Docket Item #
BAR CASE #2004-0013

ISSUE: Appeal of a decision of the Board of Architectural Review, Old and Historic Alexandria District denying a Certificate of Appropriateness for after-the-fact replacement of a front door

LOCATION: 1302 Michigan Avenue

Figure 1 The new front door as installed at 1302 Michigan Avenue

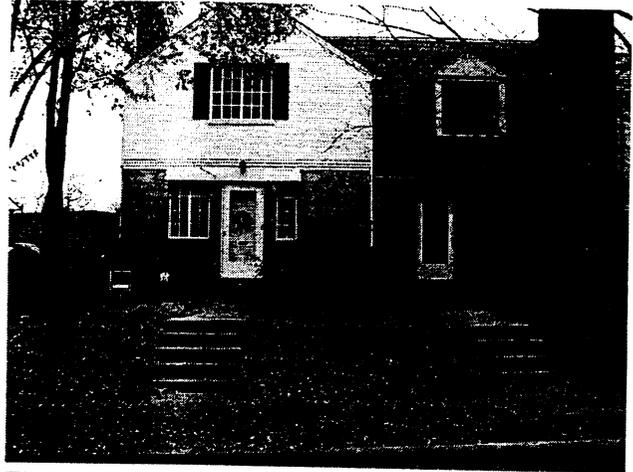
The Board denied approval of the after-the-fact installation of the new front door because it believed that (1) it was architecturally incompatible with the style of the house; (2) that it alters a character defining feature of the house; and, (3) that it will disrupt the unity found of the rowhouses in this the row.

Exterior doors and storm doors are prominent features of a building. The majority of the houses in this development have retained their original doors. Staff does not believe that the proposed decorative door is an appropriate style for the neighborhood or the historic district.
